# SAN FRANCISCO PLANNING DEPARTMENT

## Memo to the Planning Commission

*Hearing Date:* October 22, 2015  
*Case No.:* **2010.0515ETZ**  
*Project Address:* **1095 Connecticut Street and various parcels**  
*Zoning:* RM-2 (Residential – Mixed, Moderate Density), P - Public  
40-X Height and Bulk Districts  
Showplace Square/Potrero Area Plan  
*Block/Lot:* Assessor's Block/Lots: 4167/004, 004A, 4220A/001, 4223/001, 4285B/001,  
and 4287/001A  
*Project Sponsor:* BRIDGE Housing Corporation  
600 California Street, Suite 900  
San Francisco, CA 94108  
*Staff Contact:* Rachel A. Schuett – (415) 575-9030  
[Rachel.Schuett@sfgov.org](mailto:Rachel.Schuett@sfgov.org)

The action before you at your October 22, 2015 hearing is to certify the Environmental Impact Report (EIR) / Environmental Impact Statement (EIS). The Final Comments and Responses document was forwarded you last week. Attached to this memorandum is a draft Motion certifying the EIR/EIS.

POTRERO HOPE SF MASTER PLAN (CASE NO. 2010.0515E)  
FIGURE 4.3-1: VIEWPOINTS LOCATION MAP

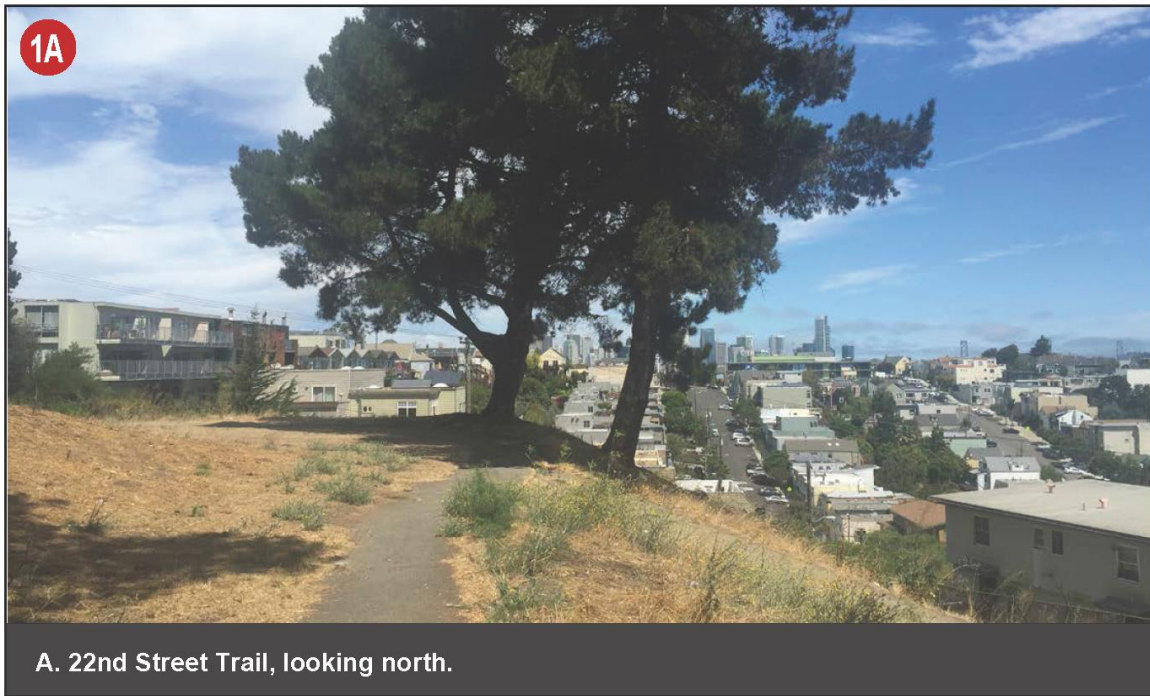
viewer locations, which include parks, publicly accessible buildings, and sidewalks that offer a view of the urban and natural landscape making up a viewshed. Since the preparation of the Draft EIR, additional views from these vantage points have been added to the analysis, including from the eastern terminus of the 22<sup>nd</sup> Street Trail, the bench below the tennis courts, and the Potrero Hill Recreation Center. The views from each of these nine vantage points are depicted on Figure 4.3-1 and Table 4.3-1 of the revised analysis.

Potrero Hill Recreation Center. The views from each of these nine vantage points are depicted on Figure 4.3-1 and Table 4.3-1 of the revised analysis. The existing views are depicted in Figure 4.3-2 through Figure 4.3-10 of the revised analysis. Viewpoints 1A through 1C represent views from the eastern terminus of the 22<sup>nd</sup> Street Trail and the bench below the tennis courts. Viewpoints 2A through 2C represent views from a scenic vista, in this case, looking south from the Recreation Center playfields. Viewpoints 2D through 2F show views looking east from the Recreation Center playfields. Viewpoints 3 through 7 represent public views of and through the Project site from outside the Project site. For the purposes of the NEPA analysis, a view of scenic resources is defined as a public view that is broad and expansive and of a significant landscape feature or of a significant historic or architectural feature. In the vicinity of the Project Site, the views from portions of Recreation Center and the 22<sup>nd</sup> Street Trail are considered scenic with high viewer sensitivity due to the nature of the use and the views of the Bay, East Bay Hills, San Francisco downtown, San Bruno Mountain, and McLaren Ridge from certain public areas of the park.

POTRERO HOPE SF MASTER PLAN (CASE NO. 2010.0515E)  
**FIGURE 5.3-1: PROPOSED PROJECT, 22ND STREET TRAIL, LOOKING NORTH (VIEWPOINT 1A)**

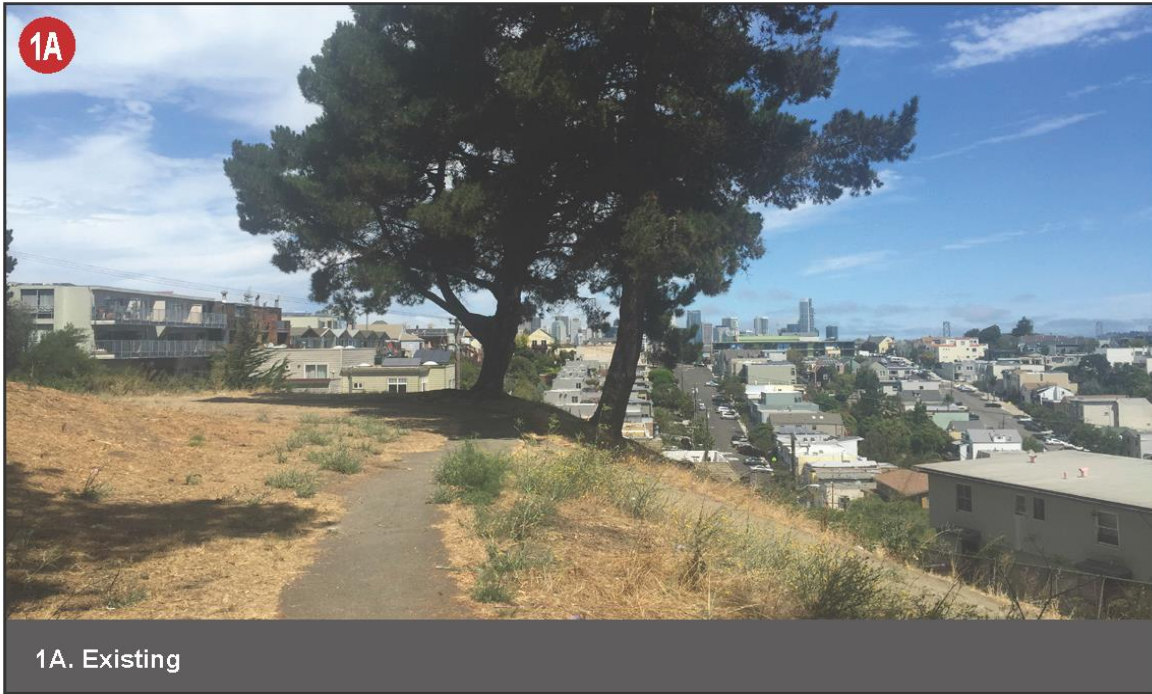
The views from the eastern terminus of the 22<sup>nd</sup> Street Trail and the bench below the tennis courts are depicted in Figures 5.3-1 through 5.3-4 (Viewpoint 1A through 1D) and analyzed under Impact AE-1 of the revised analysis. As discussed, views looking northeast and southeast afford a nearly panoramic view of the San Francisco downtown area, the Bay Bridge, the Bay, and the East Bay Hills and viewer sensitivity is considered high from this location. As shown in Figure 5.3-1 and 5.3-2, the Project would not substantially obstruct these views and changes to the viewshed from the eastern terminus of the 22<sup>nd</sup> Street Trail are considered less than significant. As shown in Figure 5.3-3, which illustrates the view looking south from the 22<sup>nd</sup> Street Trail, the Project would not introduce elements into a currently unobstructed view. Finally, the view from the bench below the tennis courts, as shown in Figure 5.3-4 would not be affected by the Project due to the vegetative screening and because development is a common visual element in this view.

*22<sup>nd</sup> Street Trail (Viewpoint 1).* As shown in Figure 5.3-1 Photo A, the northern portion of the Recreation Center includes natural features and the 22<sup>nd</sup> Street Trail. Looking east, a channelized view of the Bay and East Bay Hills is provided through the dense vegetation. Viewer sensitivity would be high from this location but the view would be of only moderate quality given that it is somewhat restricted and narrow. Under the Proposed Project, as depicted in Figure 5.3-1 Photo A, a small portion of the proposed 50 and 40 foot high buildings would be visible from the trail. From this vantage point, the proposed buildings intrude somewhat into the middleground views, which include visible urban development such as warehouses and industrial uses. However, the Bay and the East Bay Hills would still be visible from this location and would not be substantially obscured by the proposed buildings. As shown in Figure 4.3-2, the existing view from the eastern terminus of the 22<sup>nd</sup> Street Trail affords nearly panoramic views of the San Francisco downtown area, the Bay Bridge, the Bay, and the East Bay Hills. Viewer sensitivity is considered high from this location and the view is also considered to be of high quality given the high vividness, intactness, and relative unity of this viewpoint. Under the Proposed Project, as depicted in Figure 5.3-1, Viewpoint 1A, the Project would slightly open up the vista by removing the existing buildings at Potrero Annex currently visible from this viewpoint. The

POTRERO HOPE SF MASTER PLAN (CASE NO. 2010.0515E)  
FIGURE 5.3-8: PROPOSED PROJECT, POTRERO HILL RECREATION CENTER,  
LOOKING EAST FROM PLAYFIELDS (VIEWPOINTS 2D, 2E, 2F)

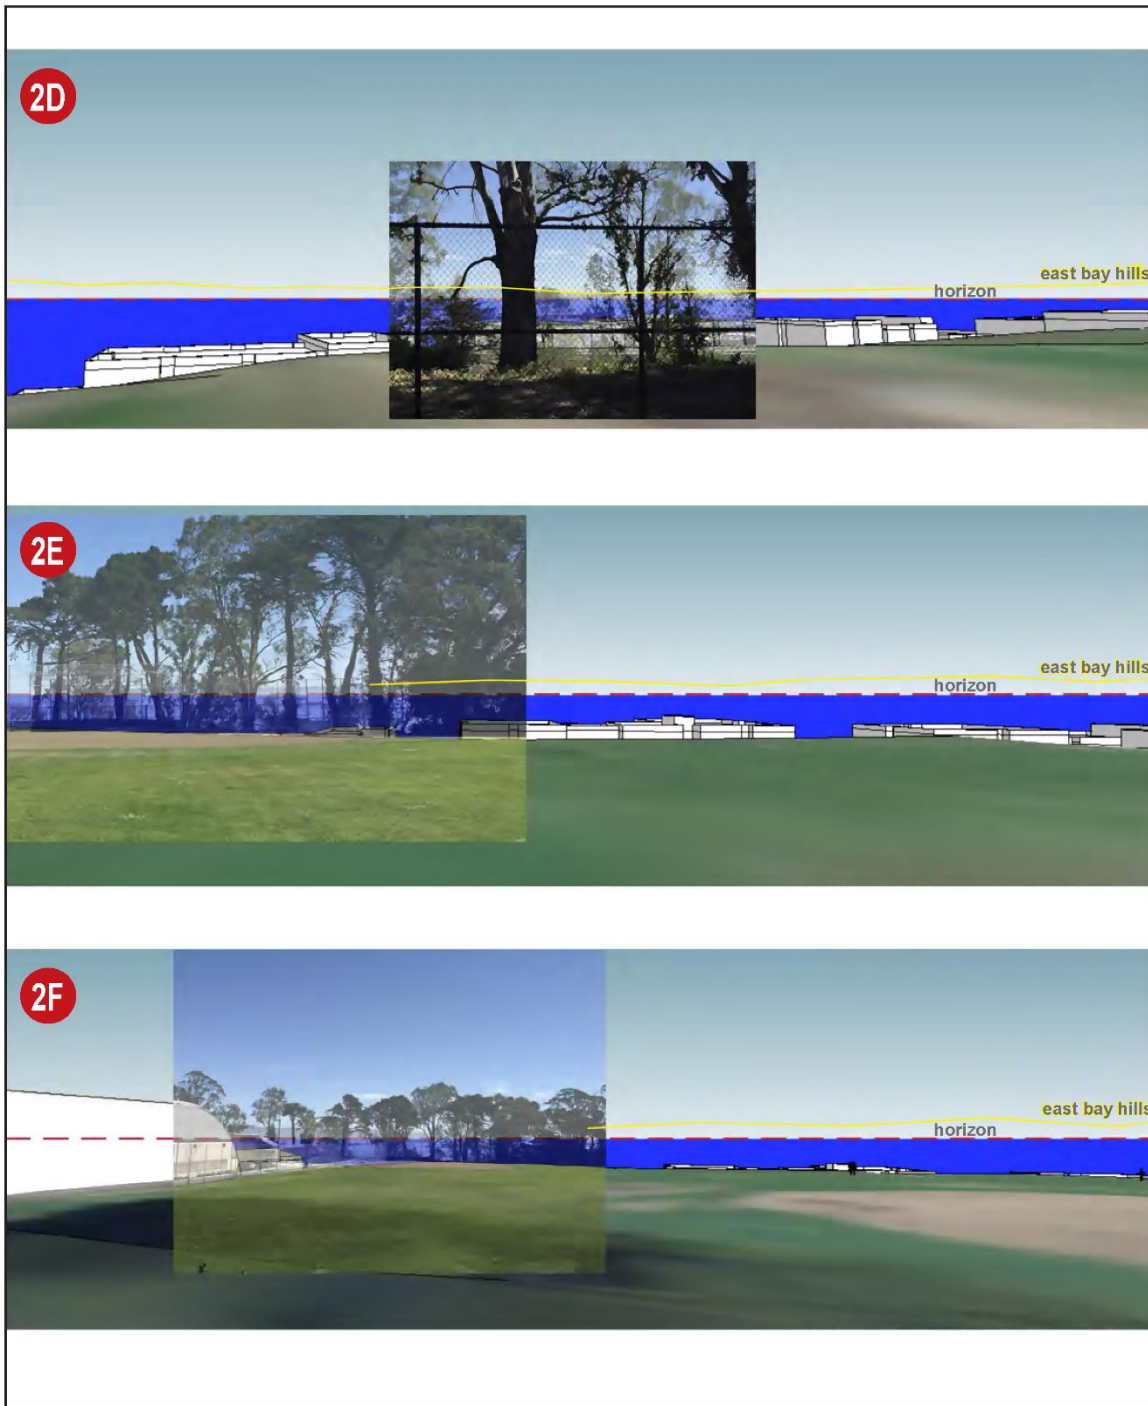
As shown in Figure 5.3-8 of the revised analysis, views looking east from the Potrero Hill Recreation Center playfields would not be affected by the Project due to the steep slopes adjacent to the park. Furthermore, these views are dominated by existing dense vegetation that obscures views to the east. The vegetation would remain following Project implementation.

POTRERO HOPE SF MASTER PLAN (CASE NO. 2010.0515E)  
**FIGURE 5.3-9: PROPOSED PROJECT, 23RD STREET AT WISCONSIN STREET, LOOKING EAST (VIEWPOINT 3)**

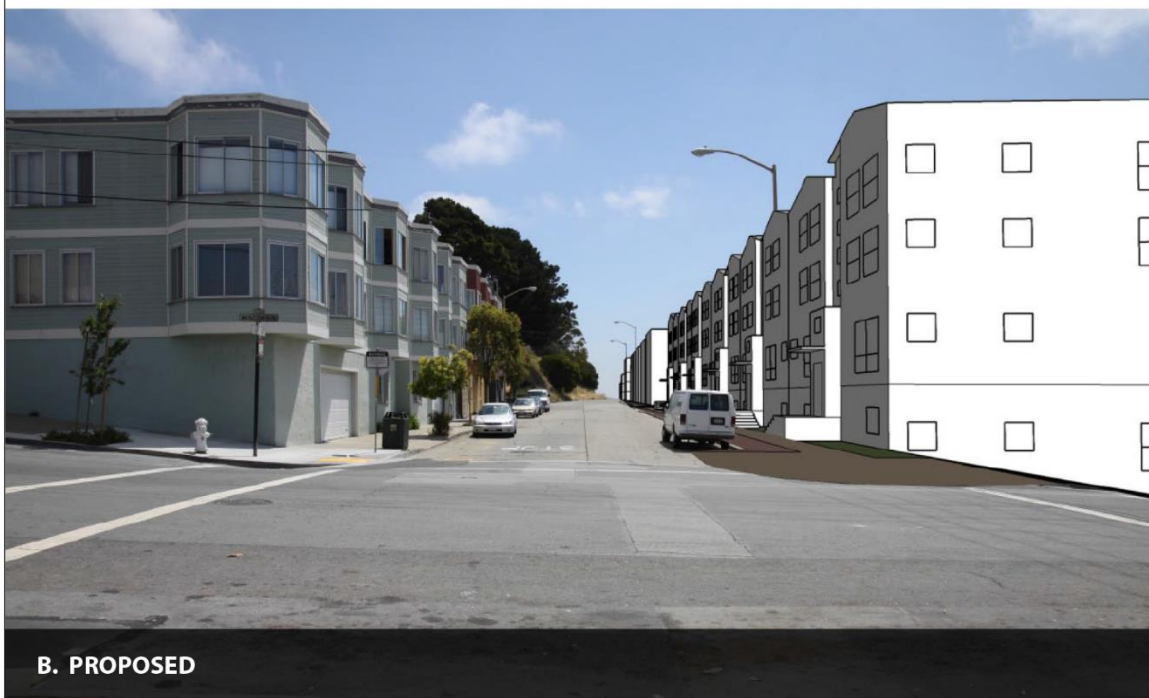
*Intersection of 23<sup>rd</sup> Street and Wisconsin Street (Viewpoint 3).* As shown in ~~Figure 5.3-3~~ Figure 5.3-9 Photo A (Viewpoint 3), the existing foreground view facing east on 23<sup>rd</sup> Street consists of multi-family residential units to the north of 23<sup>rd</sup> Street, street pavement, overhead utility wires and poles, and a chain-link fence surrounding the Project site. The middleground views encompass mature trees at the Recreation Center, minimal vegetation at the Project site, and the roofs of the existing buildings at the Project site. Background views of the Bay (Viewpoint 3) and ridgelines (Viewpoint 4) are limited due to intervening vegetation and structures. The views from Viewpoint 4 of the distant ridgelines open up and become more expansive as a motorist or pedestrian travels south, but because the views would be of short duration, viewer ~~sensitivity response to changes in views from Viewpoint 3~~ would be low to moderate from ~~Viewpoint 3~~. Currently, there is little visual unity between the Project site and its surroundings, as noted.

However, the Proposed Project, as shown in ~~Figure 5.3-3~~ Figure 5.3-9 Photo B, would construct multi-family residential buildings that would be visually compatible with the existing residences on the other side of 23<sup>rd</sup> Street. Although these buildings would be approximately 40 feet, which is taller than the existing structures, they would be stepped downhill to follow the slope of the terrain, making them appear to be approximately of equal height. In addition, the existing utility wires and poles on-
